**Newcastle Power Station Project (CSSI 9837) Response to Submissions
Further Information Still Required by the Environment Protection Authority**

The EPA has reviewed the *Newcastle Power Station Project - Environmental Impact Statement Submissions Report* (RTS) (dated April 2020) and supporting documents and has determined that not all of the information requested in the EPA's letter of 13 December 2019 has been provided. The EPA's additional information requirements are provided at Attachment A to this letter.

Attachment A: Further Information Required by the EPA

Figure 6.3: ISR vs in-stack NO_x concentration from filtered US EPA ISR database

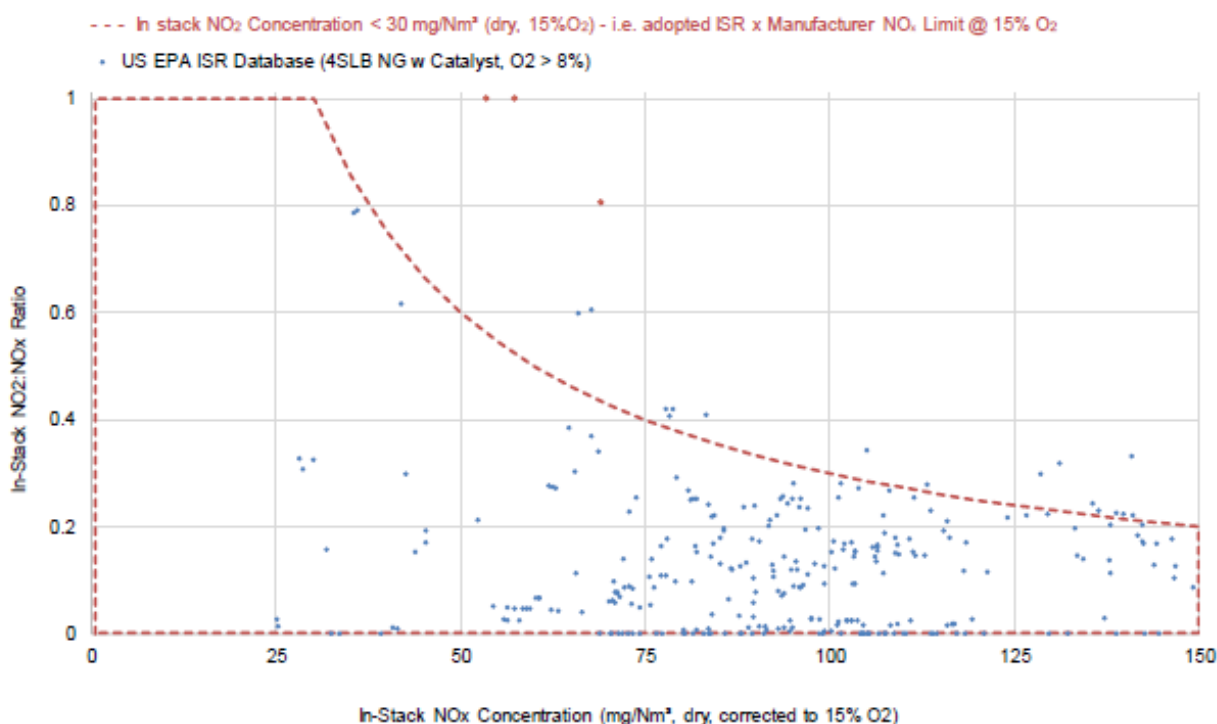
Achievable emission levels for NO_x have been demonstrated to be significantly lower than those referenced and proposed in the RTS AQIA benchmarking. This is demonstrated in the AQIA's figure 6.3 which shows in stack NO_x emissions, which are not necessarily best practice, are generally far less than 100 mg/m³ (@ 15 % O₂) and therefore the proposed 150 mg/m³ is not best practice (Figure 6.3 reproduced below).
